**BELLEFONTE COMBINED LICENSE APPLICATION – RESPONSE TO REQUEST FOR
ADDITIONAL INFORMATION - CONTROL ROOM HABITABILITY SYSTEMS**

NRC RAI NUMBER: 06.04-06

Bellefonte Nuclear Plant, Units 3 & 4 COL Application FSAR 6.4.4.2 "Toxic Chemical Habitability Analysis"

Figure 1: Chlorine, Stability Class E, 5 m/s Wind, includes the 2 minute operator action time and the 15 cfm MCR leakage

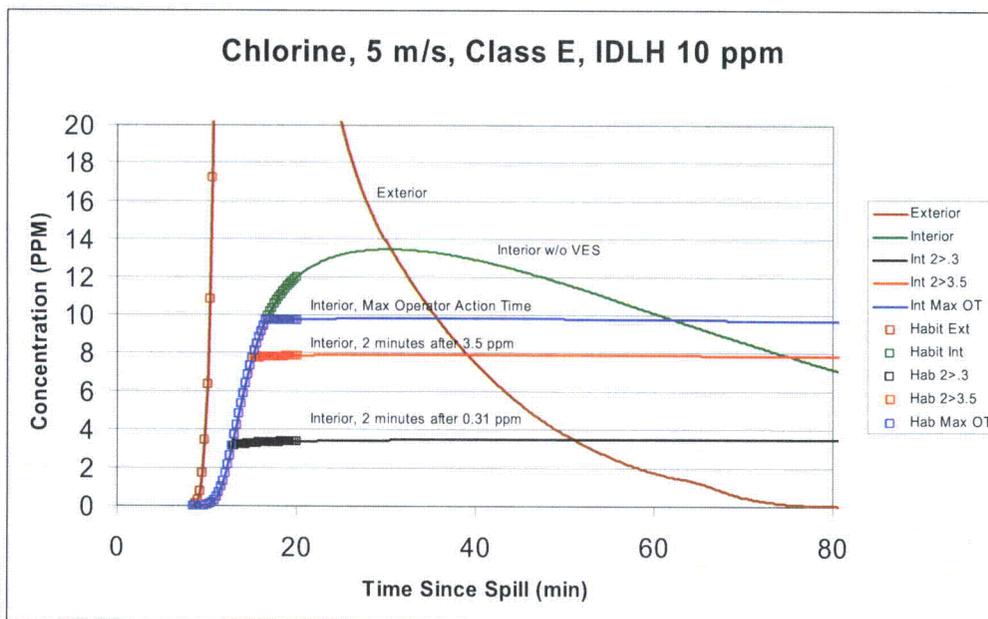
Utilizing the method provided in Regulatory Guide 1.78 Appendix A, FSAR Figure 6.4-201 indicates the presence of chlorine in the atmosphere (human detection threshold is 3.5 ppm; at approximately 12 minutes on Figure 6.4-201). As indicated in Regulatory Guide 1.78, it is expected that a control room operator will take protective measures within two minutes after detection. Procedures require that control room personnel manually activate VES in the event of a chlorine gas release that affects the control room environment.

Figure 6.4-201 only simulates VBS operation for more than 20 minutes. Control room chlorine concentration after the switching from VBS to VES is missing. Please provide the computer simulation that should continue to cover the VES portion of operation to demonstrate chlorine concentration in the control room does not exceed the limit.

Also, the control room inleakage rates are not considered for the VBS simulation. The VBS inleakage is higher than the leakage rate during VES operation per DCD. Westinghouse is revising (Westinghouse letter dated May 4, 2009) its design to allow 15 cfm control room unfiltered inleakage (10 cfm through control room envelope plus 5 cfm through vestibule doors ingress/egress) during VES operation. Any revised VBS and VES control room inleakage should be considered in the computer simulations.

An additional analysis was performed for chlorine with an assumed odor detection threshold at 3.5 ppm. There is a considerable range of published chlorine odor detection thresholds. The value of 0.31 ppm used in response to RAI 02.02.03-08 is taken from an EPA source. Other sources, such as the "Handbook of Industrial Toxicology and Hazardous Materials" (by Nicholas P. Cheremisinoff, published by CRC Press, 1999) list 3.5 ppm. NUREG/CR-6624 (Recommendations for Revision of Regulatory Guide 1.78) lists AIHA odor detection threshold of 0.08 ppm for chlorine. Considering the lower NUREG/CR-6624 odor detection threshold value, the values selected for this analysis are more conservative. A web search identified the reasons for this variability as differences between individuals, and, alternatively, as the impact of a tolerance effect "tuning out" the odor (olfactory fatigue). The odor detection threshold value of 3.5 ppm for chlorine is between the value of 0.31 ppm and the maximum operator action time event investigated. Both 0.31 ppm and 3.5 ppm odor detection thresholds are used in the analysis with results provided in Figure 1.

As shown in Figures 1 and 2 below, the MCR concentration stays well below IDLH if the VES is activated two minutes after MCR interior chemical concentrations reach the chemical odor detection threshold. This is true for the hydrogen fluoride odor detection threshold of 0.04 ppm and for chlorine whether the EPA-generated 0.31 ppm odor detection threshold is used, or the more conservative 3.5 ppm threshold is used.
